ADA Master Plan for the District of Columbia

September 20, 2011

Randall Park Pool

Building #51B
10 I Street, SW
Washington, DC 20024

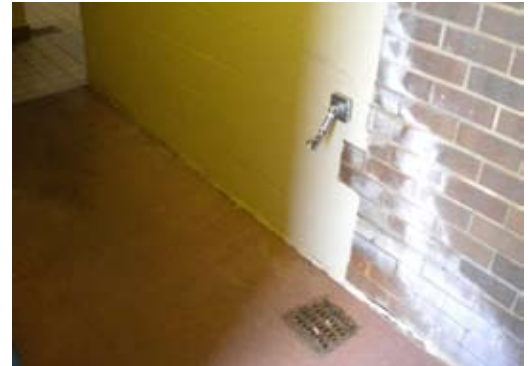
- The vestibule size and configuration at both changing room entries does not provide the required clearance for ADA compliance (Picture 21).
Action: Remove walls and doorways. Rebuild vestibule to provide required clearance.

- Spray nozzles are provided at the vestibule entry areas leading into the pool area and they impede into the accessible route (Picture 7).
Action: Provide and install shallower spray nozzles to meet ADA requirements.

- Typically, interior door closers required excessive force to open and their delay times for closure were too quick for compliance.
Action: Closers should either be adjusted per requirements or replaced as necessary.

- Hooks are provided in the Men's Changing Area, but they are not located within the accessible range for ADA compliance (Picture 22).
Action: Remove / relocate hooks to be within allowable reach range.

- The primary user group for this facility is children of all ages. No plumbing fixtures for children's use are provided in either Men's or Women's Toilet Rooms.
Action: Provide and install plumbing fixtures for children's use to meet the ADA requirements.

- Typical Locker Room mirror height is greater than required.
Action: Remove and reinstall mirrors at corrected height.
- Accessible toilet stalls are provided in both Men's and Women's Toilet Rooms; however, they include sinks that interfere with the required clear space (Picture 8).
Action: Remove sink and provide accessible toilet stall that meets ADA requirements.

- Urinals in Men's Locker Room exceed the required height for compliance (Picture 9).
Action: Provide accessible urinal at corrected height.

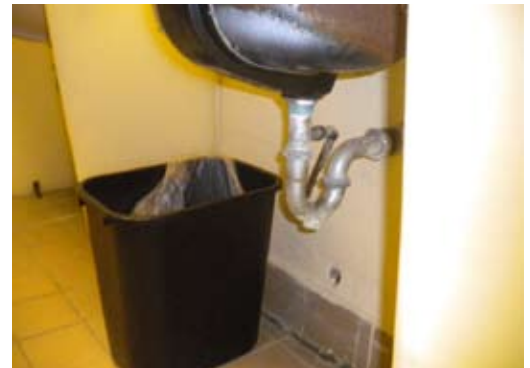
- The required pipe protection (insulation) under the sinks in both Locker Rooms is missing (Picture 10)
Action: Provide and install pipe padding to bring sinks into compliance.

- Existing sinks are above allowable height for compliance (Picture 11).
Action: Remove and relocate sinks below maximum height to meet ADA requirements.

- Faucet controls in both Locker Rooms require hard grasping and turning of the wrist, which is not compliant (Picture 11).
Action: Provide ADA compliant faucet controls.

- Toilet compartment configurations at sink locations prevent the required approach dimensions for ADA compliance (Picture 11).
Action: Remove plumbing fixtures and accessories. Rebuild to provide required clearance.

- Shower units are provided on the perimeter walls of both the Male and Female Changing Rooms. Accessible showers with required accessories are not provided, which is not ADA compliant (Picture 12).
Action: Provide accessible shower unit in each shower bay.

- Changing stalls are provided in Women's Changing Area, but no accessible stall is included (Picture 23).
Action: Provide accessible changing stall for ADA compliance.
